PRYING EFFECT ON CONCRETE EXPANSION ANCHOR BOLTS  
DUE TO PIPE SUPPORT BASE PLATE FLEXIBILITY

RAI 210.71

SEABROOK PROJECT

PSNH—SEABROOK STATION

A. CALCULATIONS FOR SQUARE PLATE WITH FOUR BOLTS

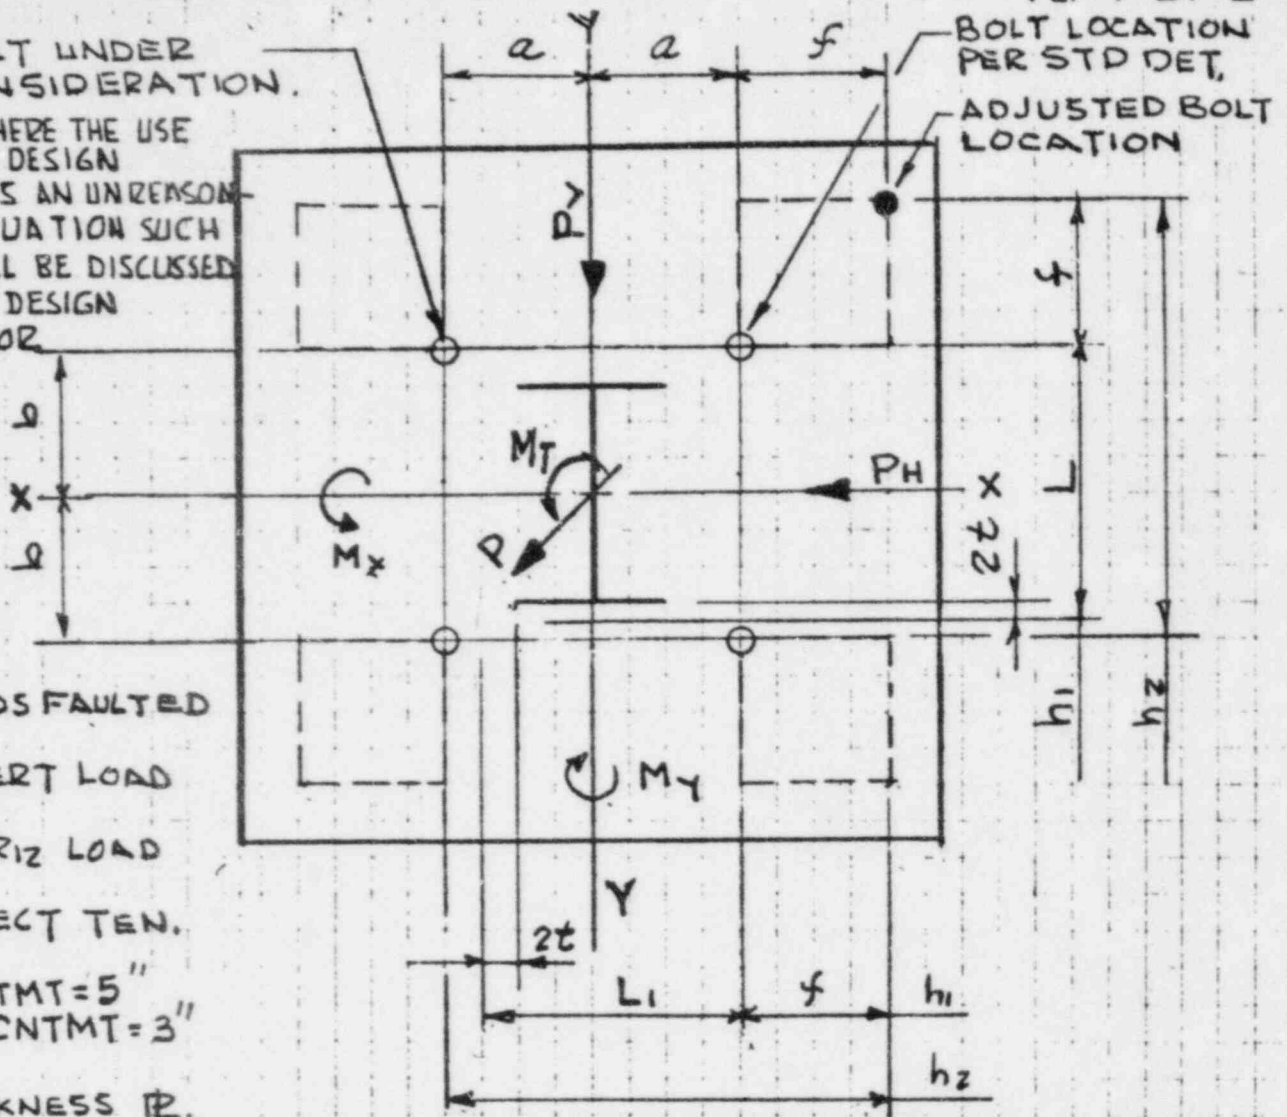
Provide a numerical example for each of the following flexible plate and bolt configurations showing the calculation of allowable axial loads and bending moments.

- a. Square plate/four bolts, either bolts.
- b. Rectangular plate/six bolts.

Exhibit 210.71-1 includes calculation for the following cases:

- a. Square plate with four bolts.
- b. Rectangular plate with six bolts.

The allowable bolt loads are based on the following formula:

$$\text{Maximum Allowable Design Load} = \frac{F_u}{4}$$

Where  $F_u$  = Ultimate Static Capacity of the anchor based on manufacturers' static test for the applicable strength of concrete.

Load - Displacement curve was not used for determining the allowable loads because the design loads are within the linear portion of the curve.

BASE PLATE DETAIL

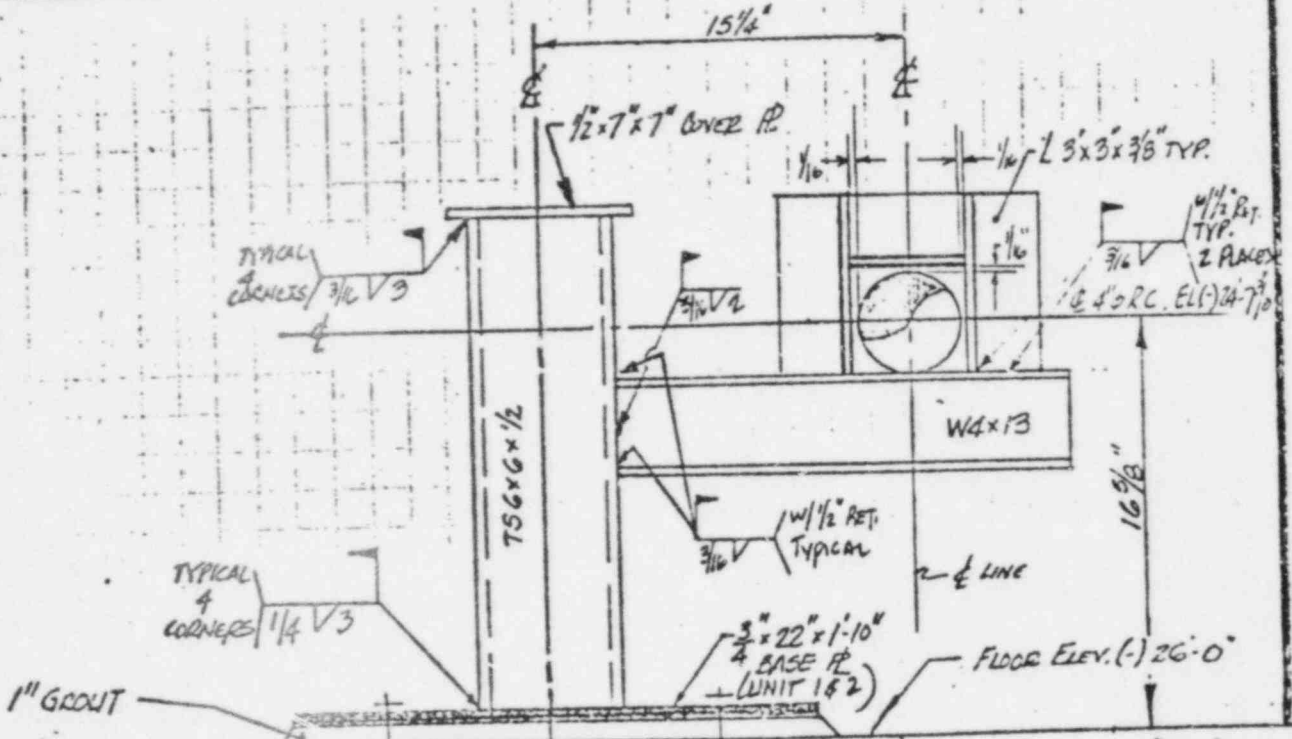
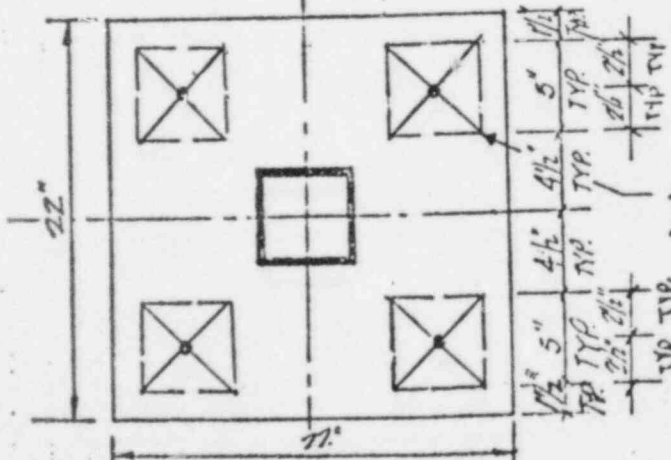
CHECK BASE  $\bar{A}$  (SEE SHEET 4 OF 14 FOR DETAIL)

$$F_x = 159 \# (P) \quad M_x = 15027 \# (M_y)$$

$$F_y = 366 \# (P) \quad M_y = 2651 \# (M_x)$$

$$F_z = 568 \# (P_H) \quad M_z = 2507 \# (M_x)$$

$$F_1 = \frac{4.5 + 5}{2(4.5) + 5} = 0.68 \quad F_2 = 0.68$$

$$T_1 = \frac{2507}{8.5} (0.68) = 201 \#$$

$$T_2 = \frac{15027}{8.5} (0.68) = 1202 \#$$

$$T_p = 366 \times 0.68 \times 0.68 = 169 \#$$

$$T_T = 1.2(201 + 1202 + 169) = 1886 \#$$

$$V_1 = \frac{159}{2} (0.68) + \frac{2651}{8(5)} = 120 \quad V_2 = \frac{568}{2} + \frac{2651}{8(5)} = 350$$

$$V_T = (120^2 + 350^2)^{1/2} = 370$$

$$I.A. = \frac{1886}{3975} + \frac{370}{4210} = 0.56 < 1.0$$

USE 4- Hilti Kwik  
BOLTS  $\frac{3}{4}$ "  $\Phi$  w/ 6"  
MIN ENB.CHECK  $\bar{A}$  BENDING

$$M_x = 2(1886) \times 6.5 = 24518 \text{ psi}$$

$$t = \sqrt{\frac{6 \times 24518}{15750 \times 22}} = 0.65 < 0.75$$

↑ USE  $\frac{3}{4}$ " THICK  $\bar{A}$
